Albion Park Quarry

Water Management Plan

Version 9 | Revision 1

Issued – March 2024

Figure 16
CLEARY BROS SURFACE WATER STORAGES

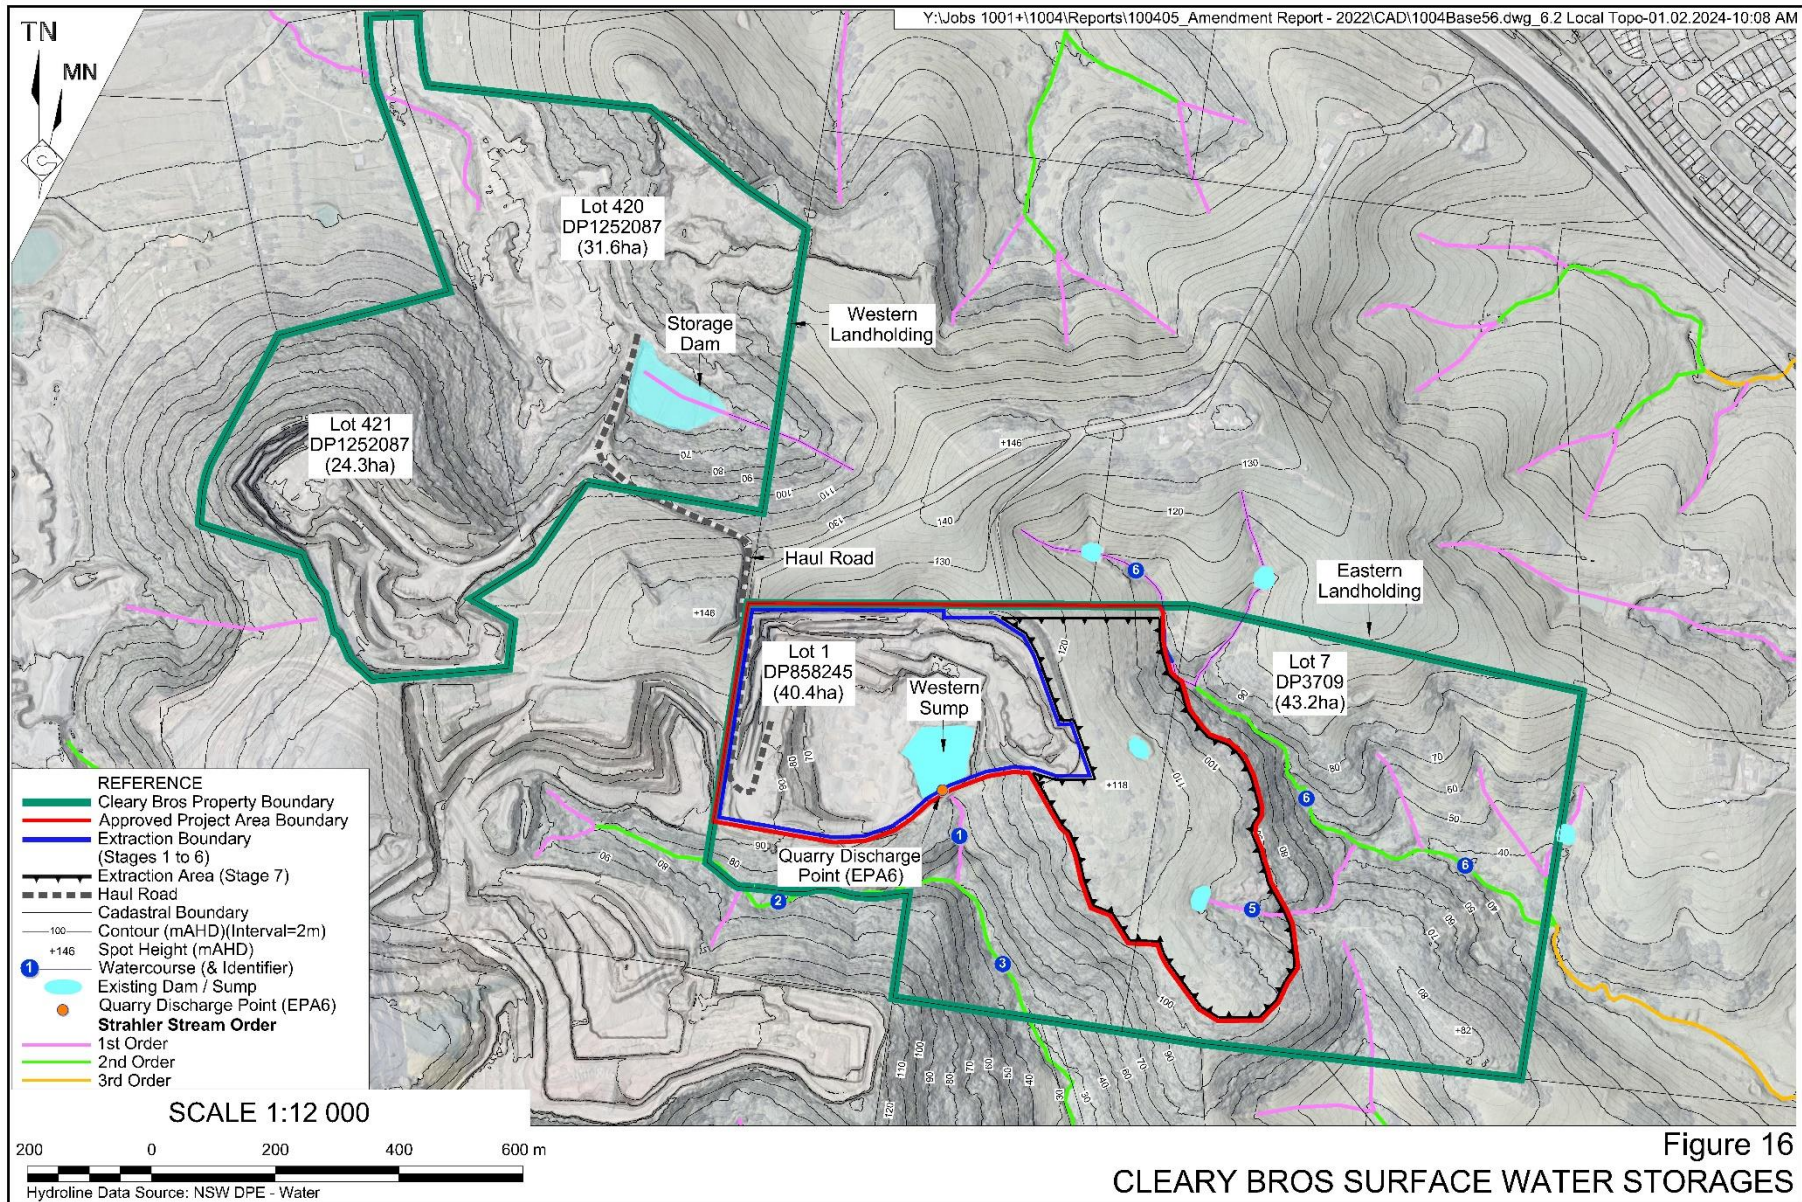
<p>Suggest remove 'Western Land Holdings' boundary on Figure 16 for ease of Management Plan interpretation.</p>	<p>Western land holdings have been retained on plan to address queries from DCCEEW in relation to the calculation of the harvestable right.</p>	No change
	<p>Erosion and sediment risks are highest during clearing. Outline details of clearance management including inspection timings and triggers to manage erosion and sediment control. More detail is needed in Section 5.3.2 regarding Stage 7a.</p> <p>Table 23 (TARP) should also include more details of erosion and sediment control management during clearing.</p> <p>Include copies of Blue Book design controls/schematics as an appendix to this management plan. Eg, Sediment dam, sediment fencing, channel design.</p> <p>Commitment to inspections and maintenance after defined rainfall events.</p>	<p>Section 5.3.2 has been amended to include additional detail in relation to establishment and progression of sediment and erosion controls.</p> <p>Sections 5.3.2 and 5.4.2 have been amended to include additional details in relation to inspection of sediment and erosion controls.</p> <p>Section 9.2 and Table 23 has been amended to present measures to be implemented in the event that inspections identify active erosion.</p> <p>Appendix 1 with copies of Blue Book standard drawings has been included.</p>	<p>Sections 5.3.2, 5.4.2 and 9.2</p> <p>Table 23</p>
